**Steven M. Clouse WRC Electrical System Improvements Phase II**  
**Solicitation Number: CO-00276**  
**Job No.: 16-6501**

**ADDENDUM 1**  
**February 22, 2021**

SHEET NO.  
**20E62**  
357 OF 500

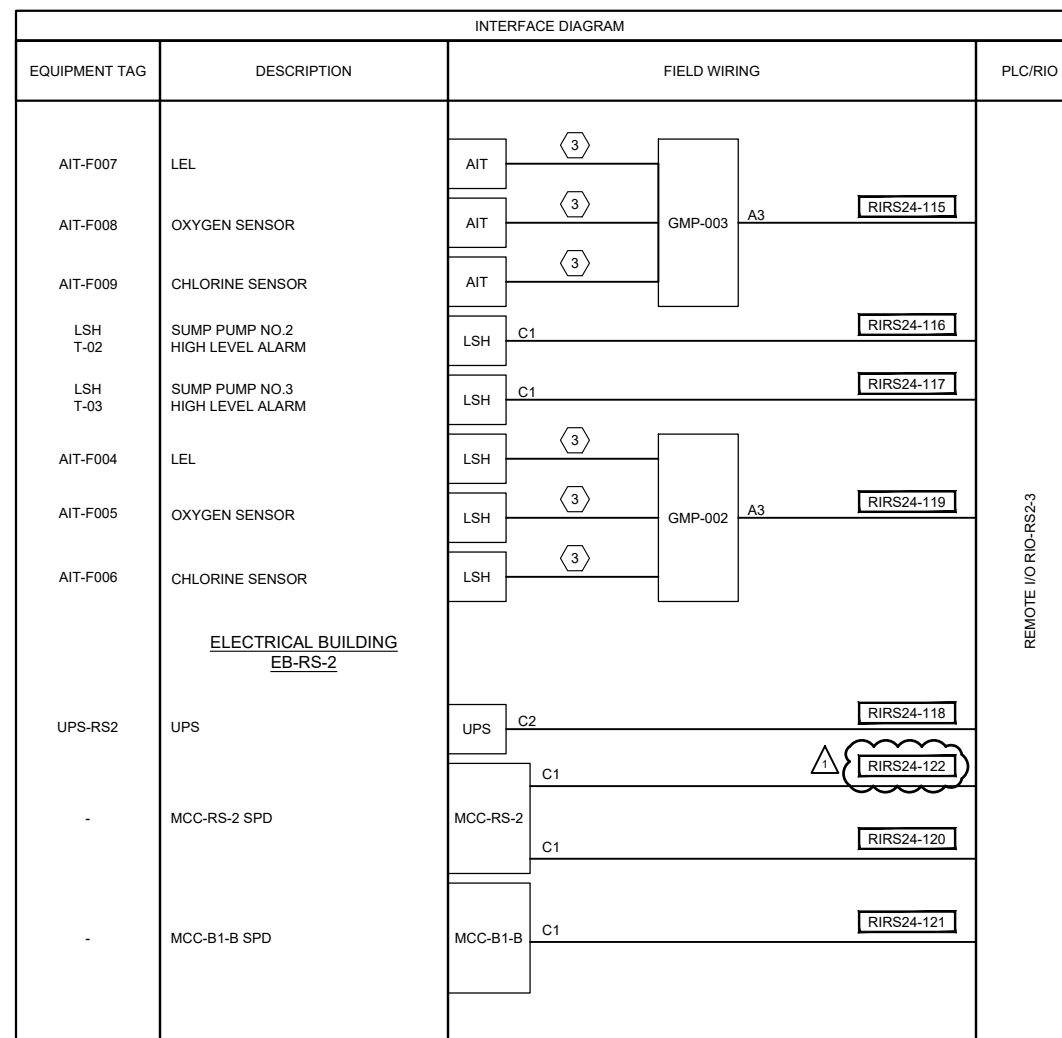
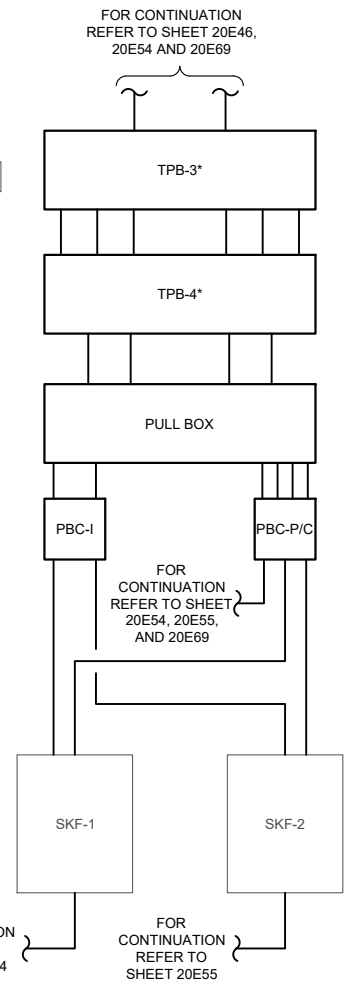
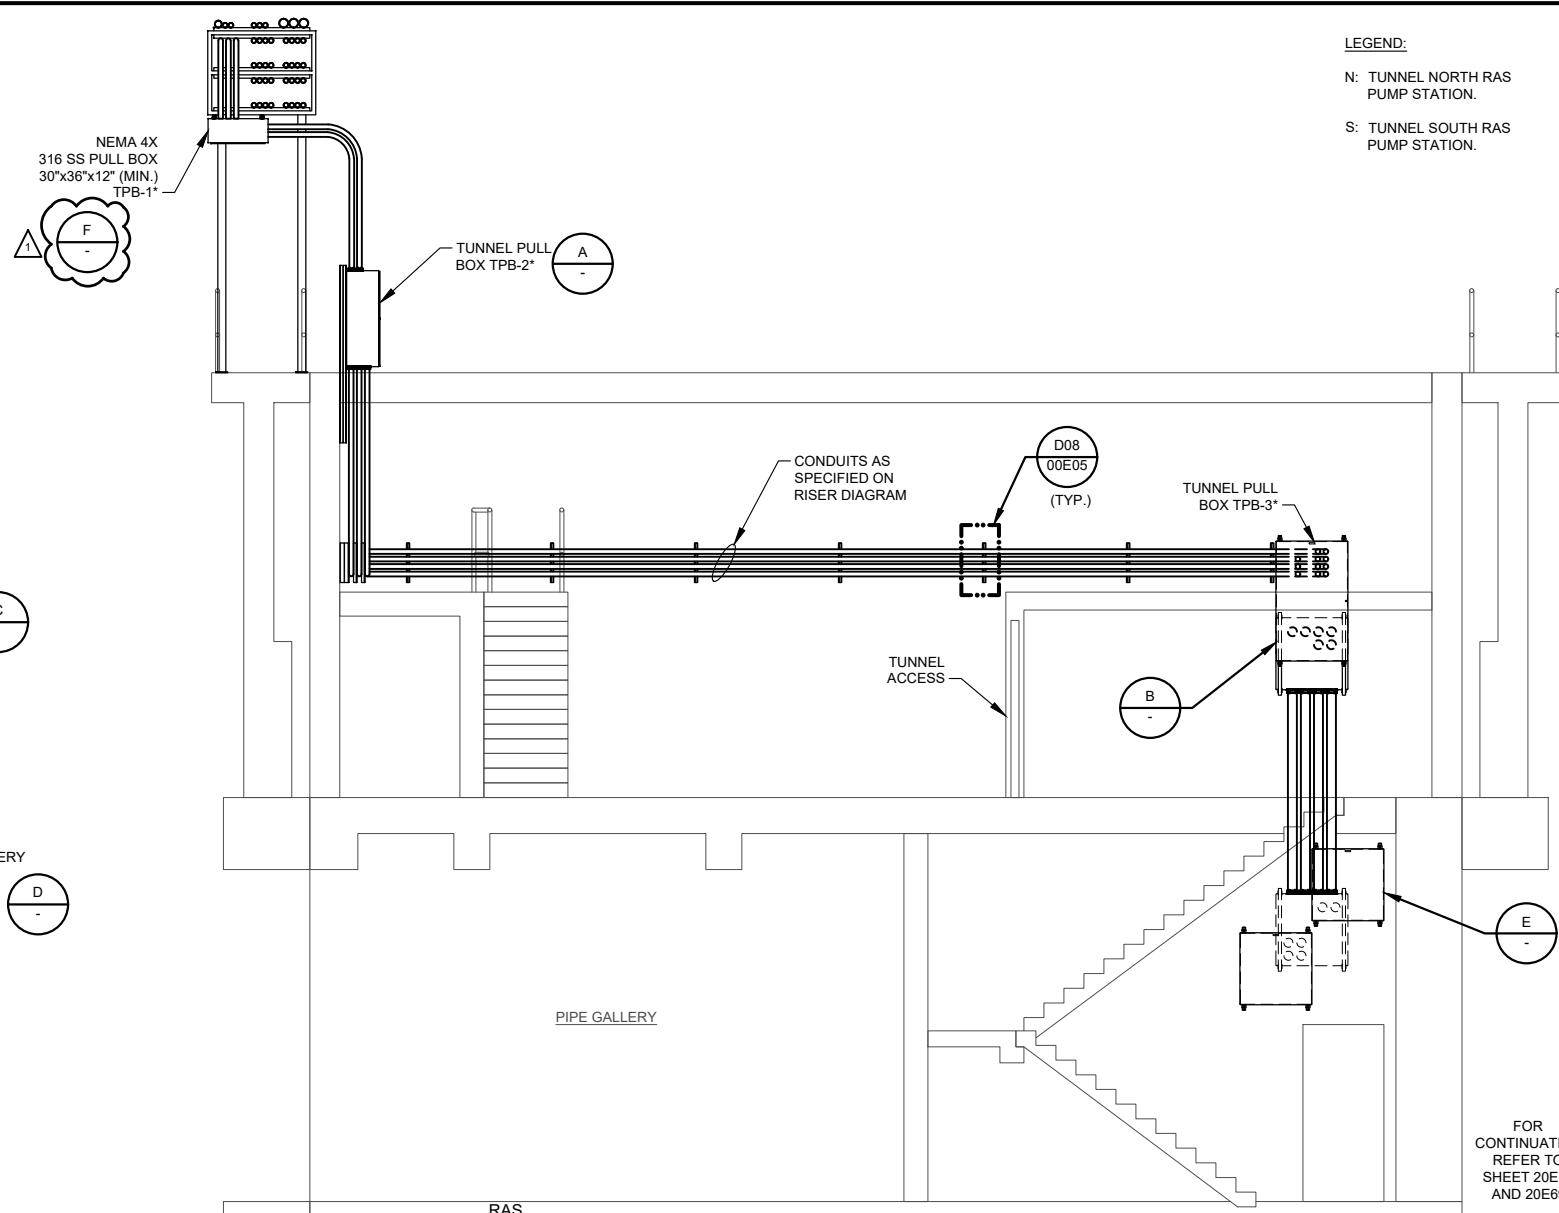
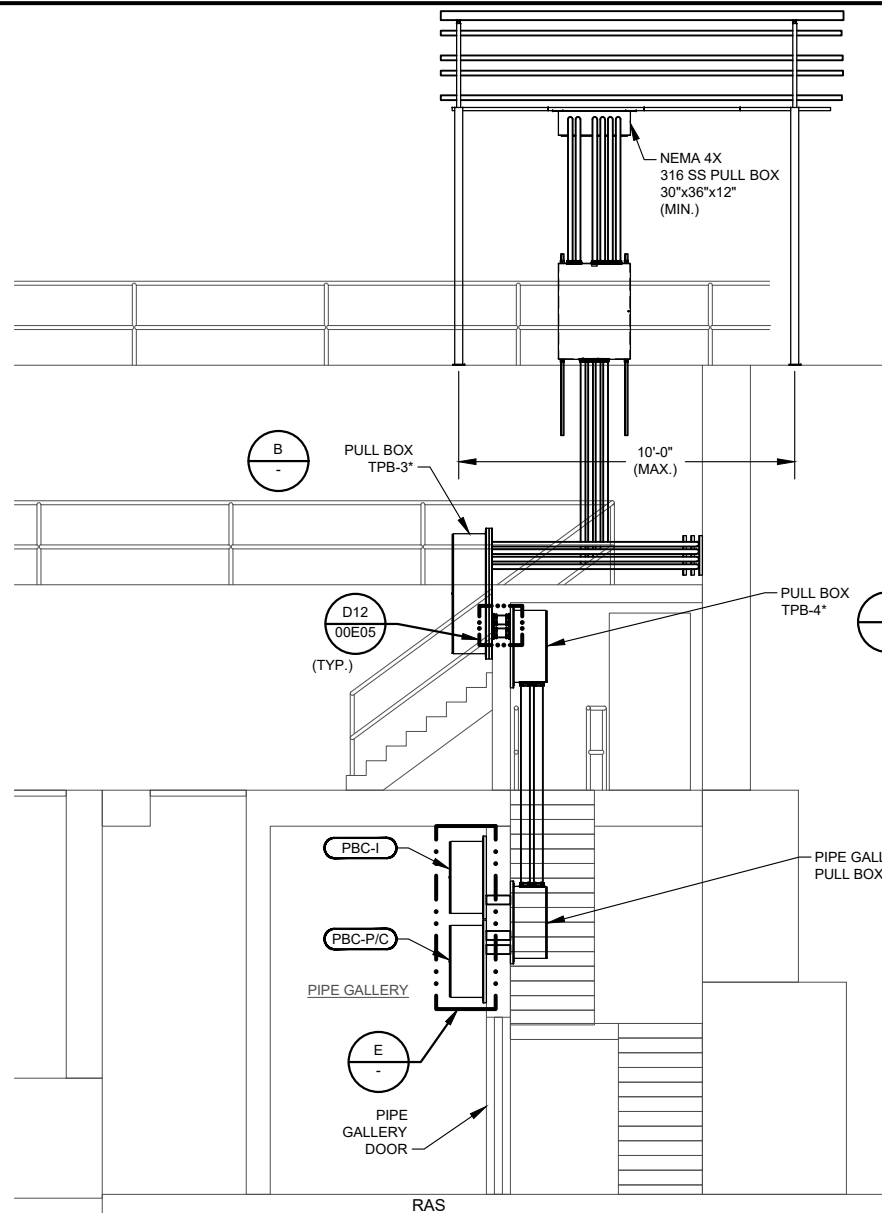
10. Drawing 20E62 RIO circuit # RIRS24-119 is utilized twice, one for Pipe Gallery cables from GMP-002 and again for MCC-RS-2. Please advise.

*Response: SPD in MCC-RS2 communication circuit changed to RIRS24-122. Refer to "Changes to the Plans," items 1.f and 1.i.*

SHEET NO.  
**20E70**  
 365 OF 500

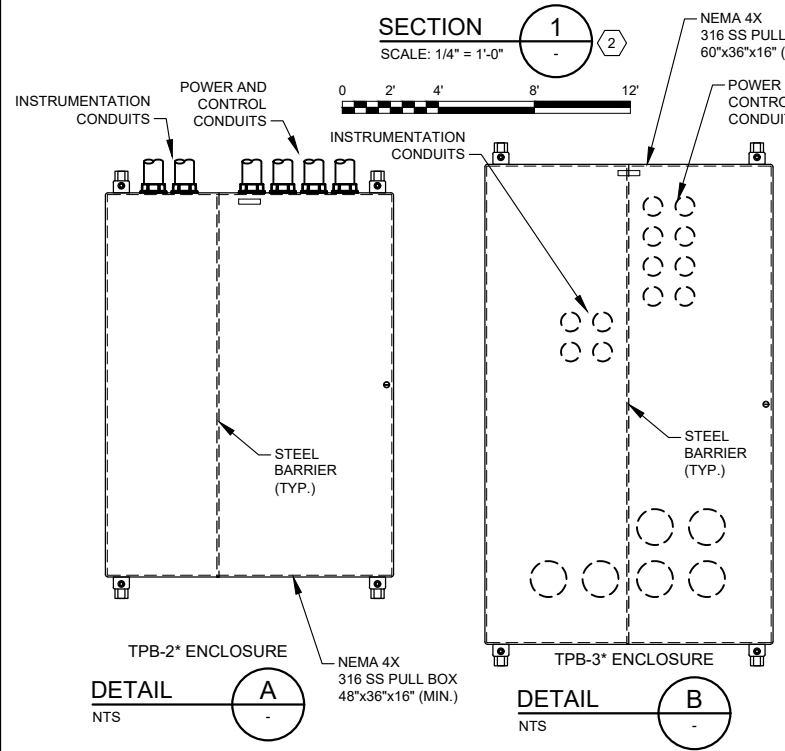
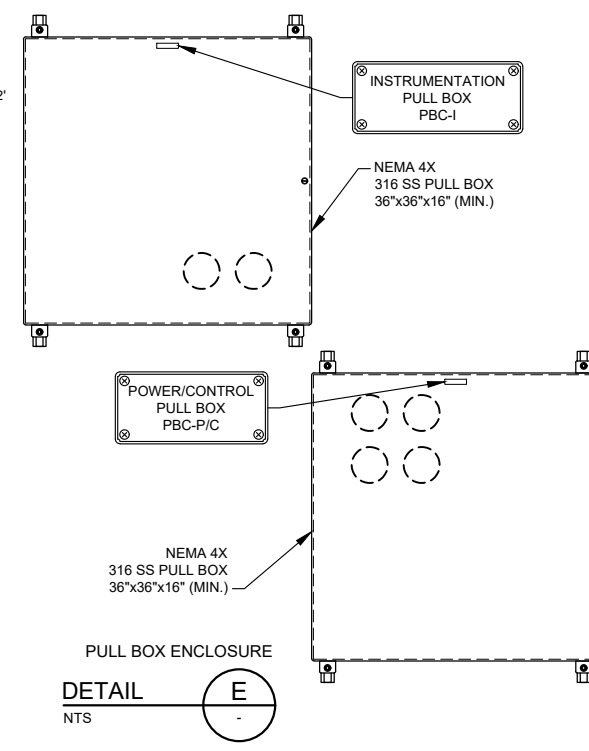
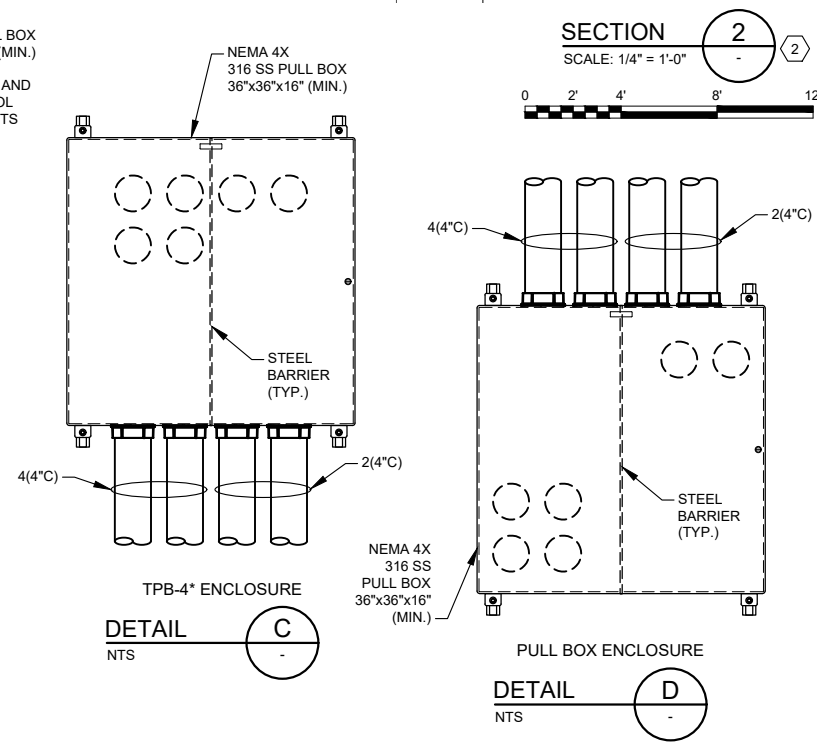
11. Drawing 20E70 Tunnel Pull Boxes TPB-2\*,3\*,4\* and Pull Box with detail D all show to have an internal steel barrier, however TPB-1\* does not, please clarify if this box requires an internal barrier as well.

*Response: Pull boxes TPB-1\* shall include steel barrier between the instrument and power sections, similar to other pull boxes. Refer to "Changes to the Plans," item 1.j.*
